MODIFICATIONS

EAGLE - Model 200

DRIVER MODIFICATION:

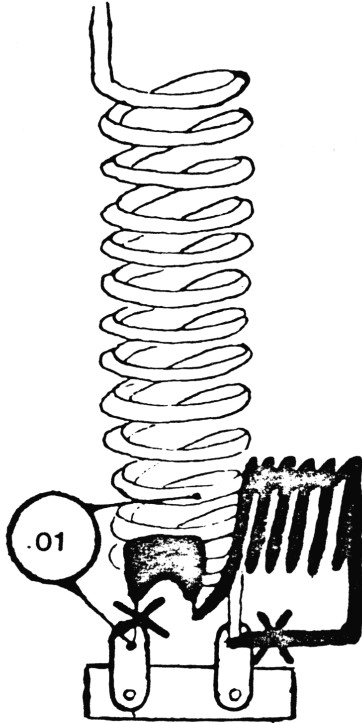
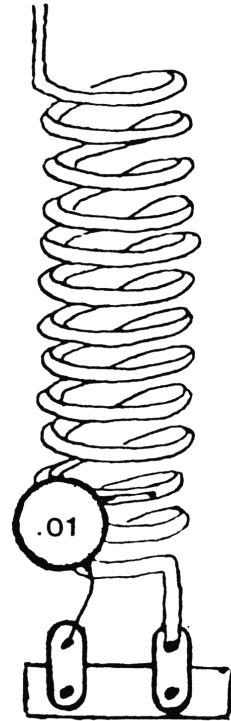
Factory Issue

After Modification

OUTPUT MODIFICATION:

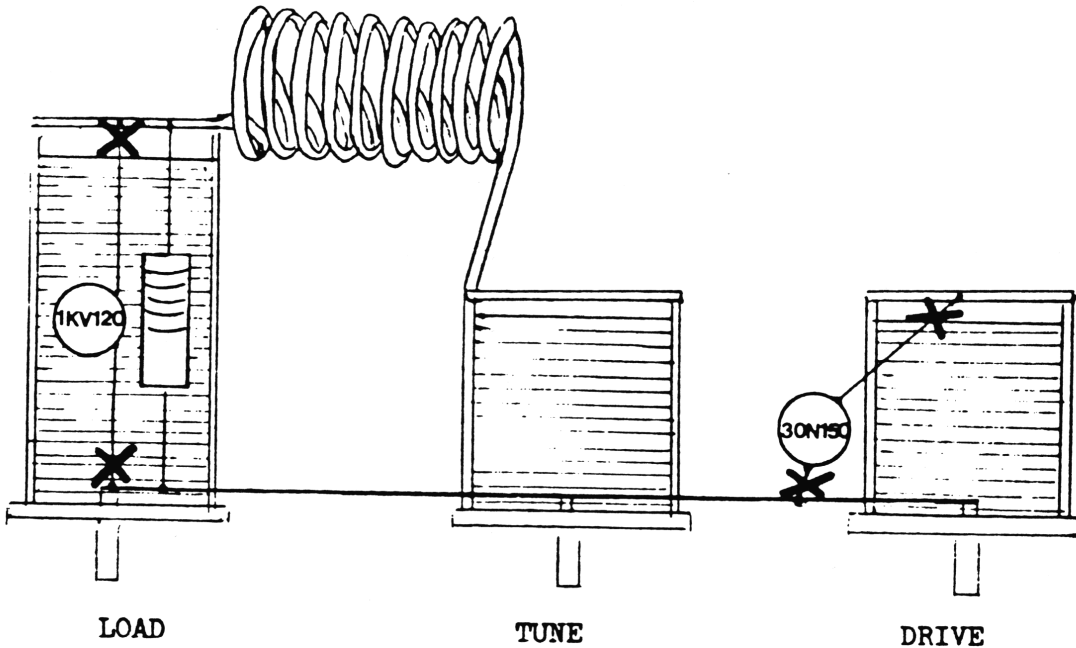
Factory Issue as depicted above. To modify, remove capacitors (1KV120 & 30N150) across "Load" and "Drive" Controls. Cut as indicated by "X's".
